Covering Note - Response to NatureScot Points (a) and (b) – River Moriston SAC

1.1 On 19 January 2026, NatureScot submitted a further updated consultation response in respect of the application for section 36 consent and deemed planning permission for the Glen Earrach Pumped Storage Hydro Scheme (the 'Application'). The NatureScot response related specifically to impacts on the River Moriston Special Area of Conservation ('SAC'). It identified five areas on which NatureScot wished to receive further information listed as items (a) to (e) relating to the SAC.

Appendix A – Responses to Points Raised by NatureScot in its Response of 25 February 2026

Figure 2-2. Extract from AECOM hydraulic modelling of loch water levels in 2023 under various scheme scenarios. The Q95 (15.40 mAOD) and Q10 (16.50 mAOD) levels are shown for context.

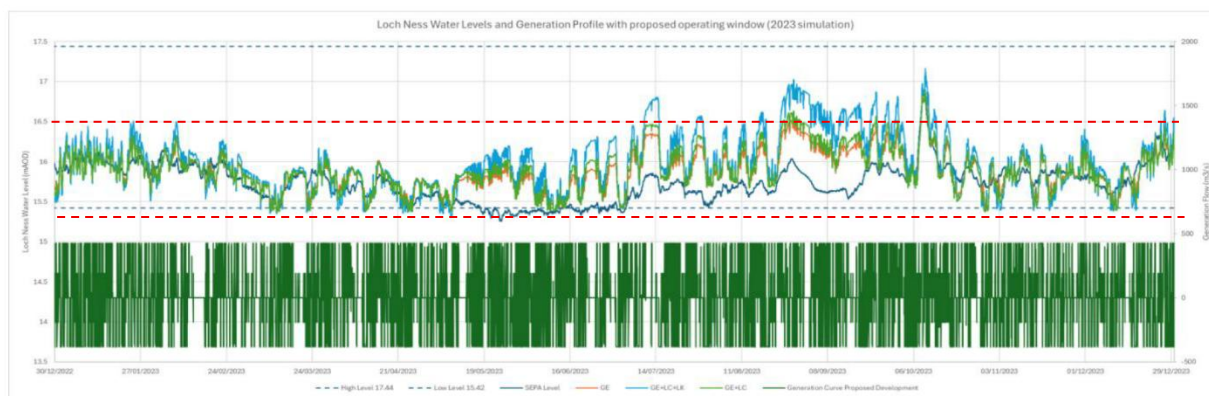
NatureScot stipulated that it should demonstrate that the fish passage would be viable under a reasonable worst case scenario including the cumulative effect of all Loch Ness water users and the effect of climate change. The design range of the proposed fish pass has been such as to provide upstream passage across a Q95 - Q10 flow window and these have been estimated as occurring at the upstream (loch) levels of 15.50mAOD and 16.80mAOD. It is unclear how these levels have included the effect of both upstream users and climate change. Levels previously modelled by AECOM and presented in the document Glen Earrach PSH - Additional Information - Addendum (Ness Woods SAC and Urquhart Bay Wood SAC) - Water Levels - September 2025.pdf indicate that the annual long term L95 and L10 (which should correspond to Q95 and Q10 over the weir) are 15.40mAOD and 16.20mAOD respectively.

*Applicant response: water levels presented in Section 2 of the Fishtek *Optioneering Summary* have now been included based on long term levels derived by AECOM. [Note that L10 is 16.50 mAOD rather than 16.20 mAOD as referenced in the above NatureScot comment].*

Figure 5 – Velocity isosurfaces at 0.092 m/s and 0.046 m/s.

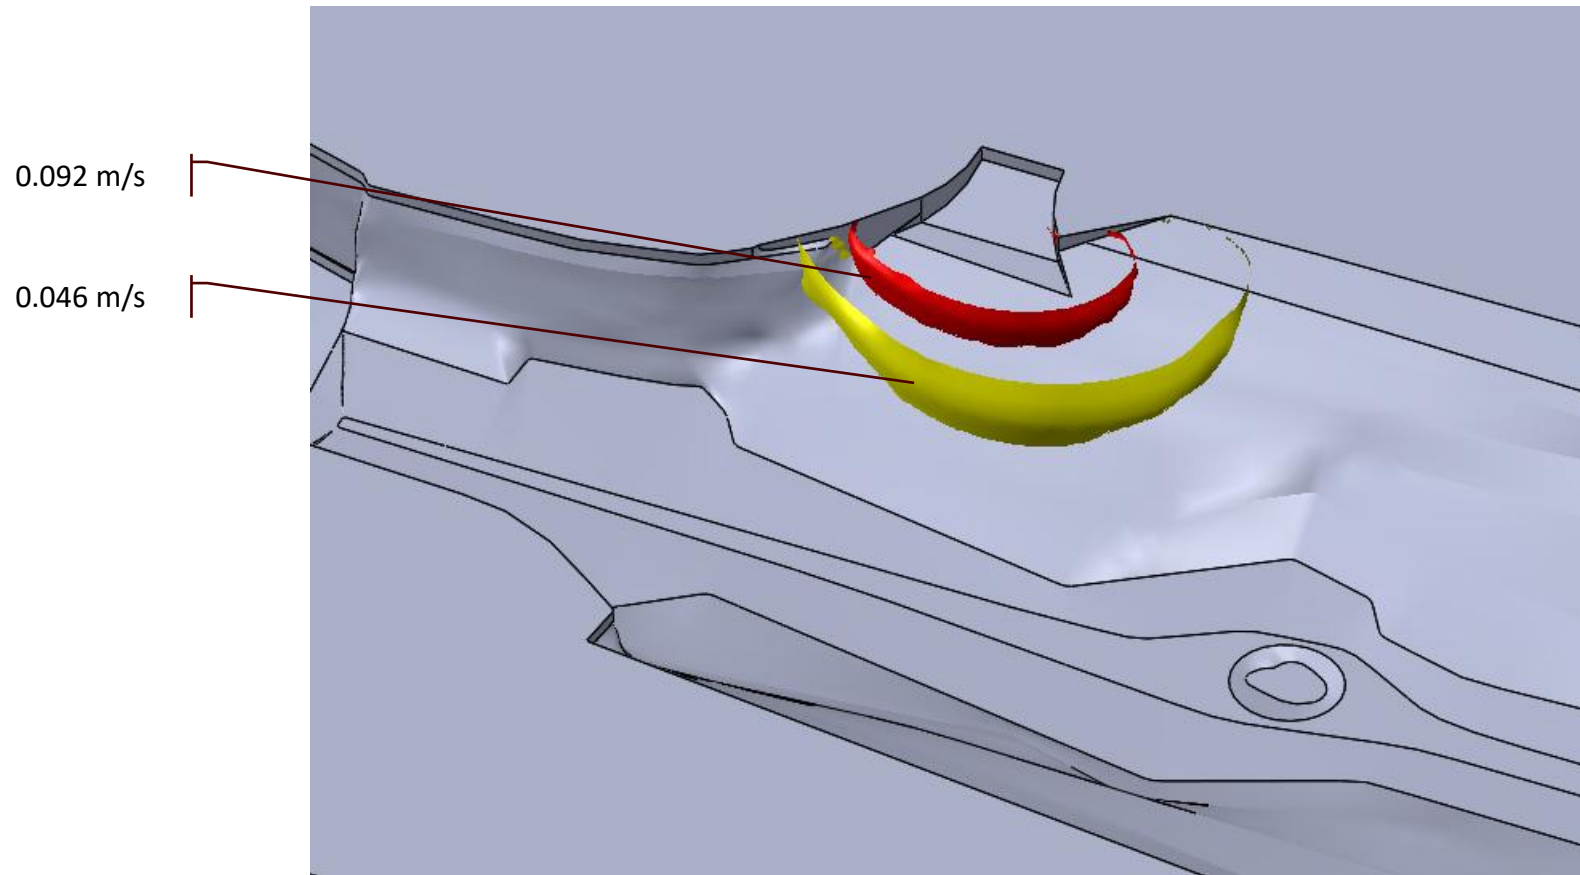
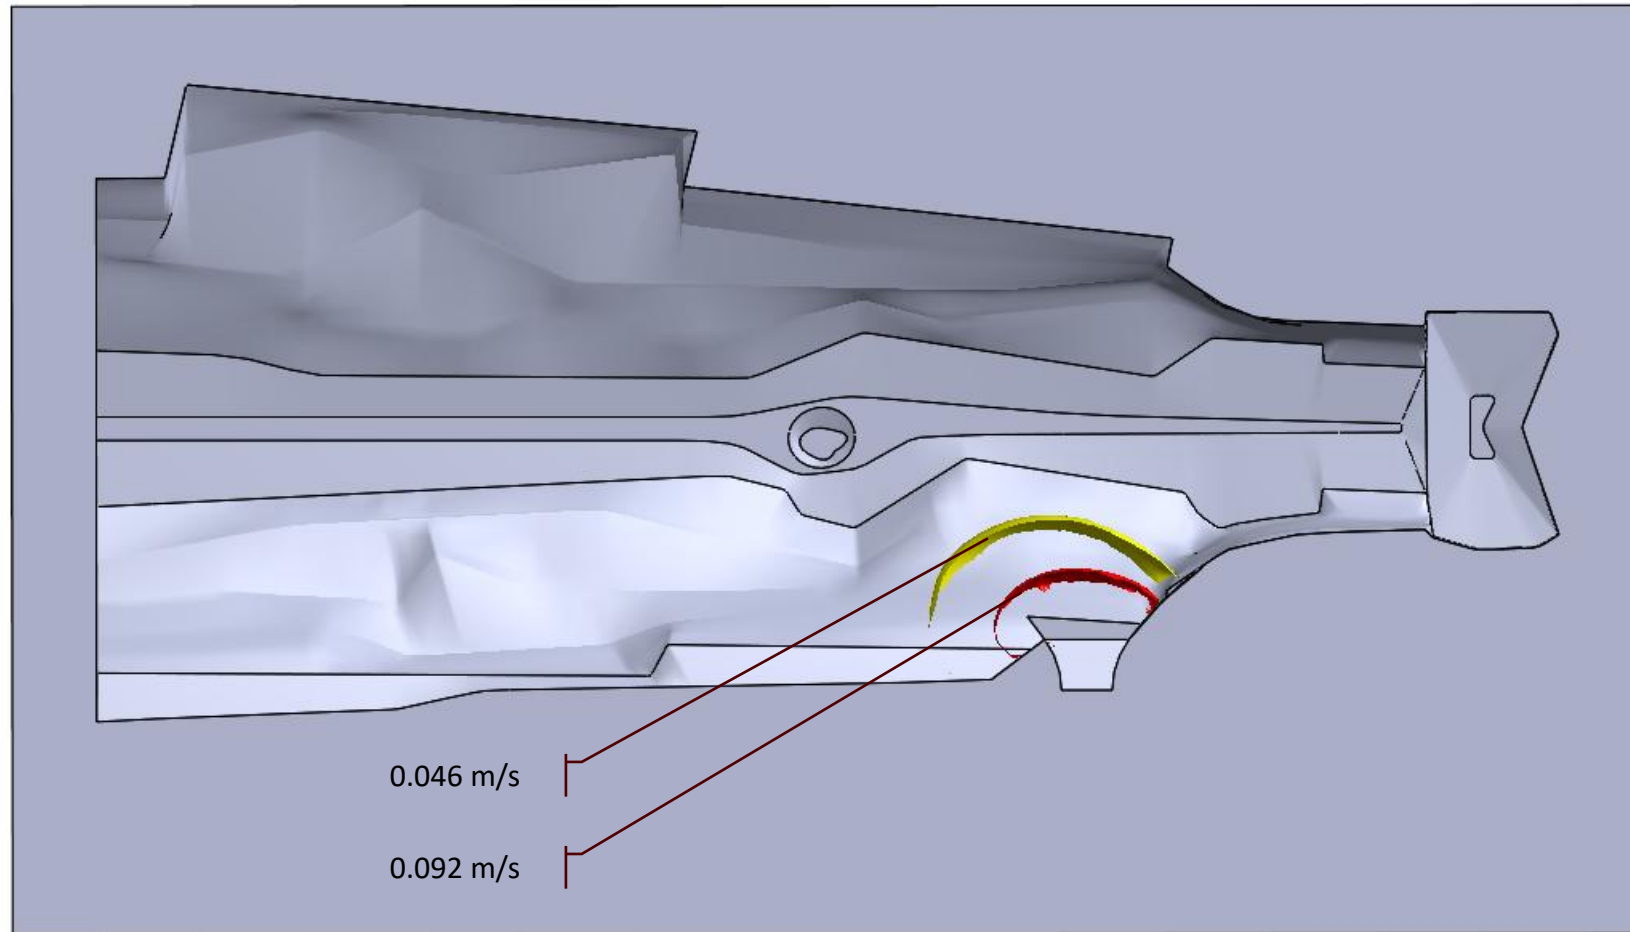
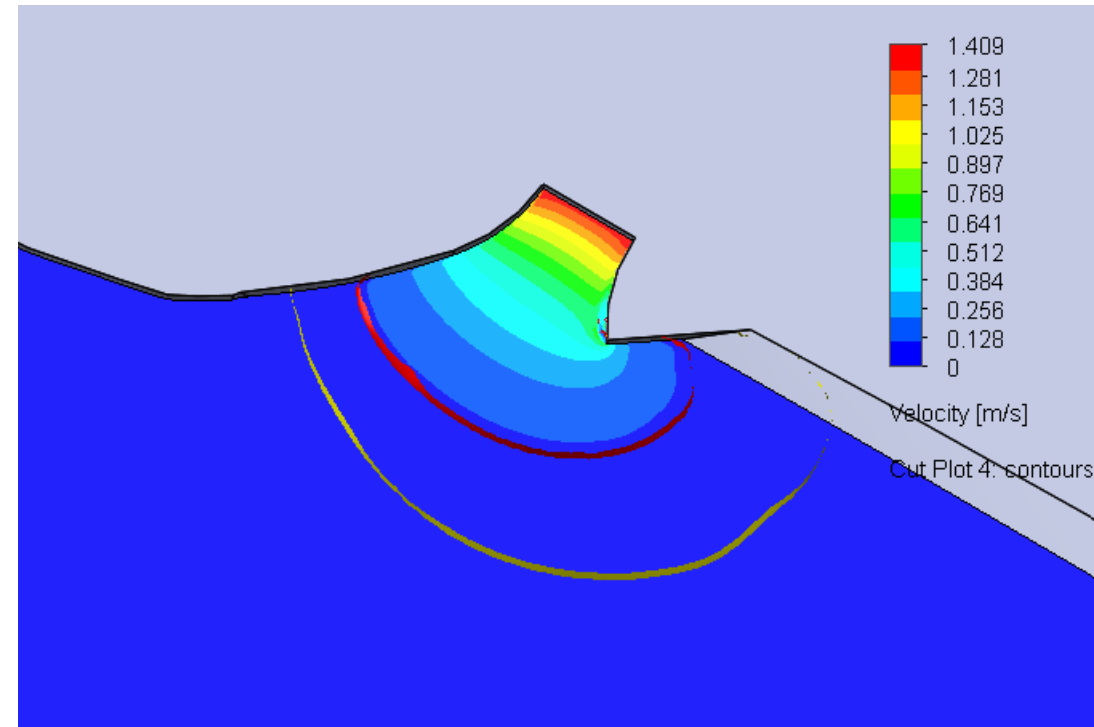
- to demonstrate that the proposed downstream passage routes for smolts and kelts will provide attraction currents of at least 0.092m/s (the lower 95% confidence interval of the mean minimum directional water velocity required to initiate a behavioural response resulting in a direction of orientation change in wild smolts (Kundegorski et. al, 2025)).

Applicant response: additional evidence and outputs from CFD modelling (Appendix 2 of *Fishtek Optioneering Summary*) have been included to demonstrate how the final smolt pass nearest Dochgarroch Lock will function, including reference to the quoted velocity threshold. It is important to note that the results from Kundegorski et. al, 2025 are of limited relevance to this arrangement – reasons for this are now included the *Fishtek Optioneering Summary*.
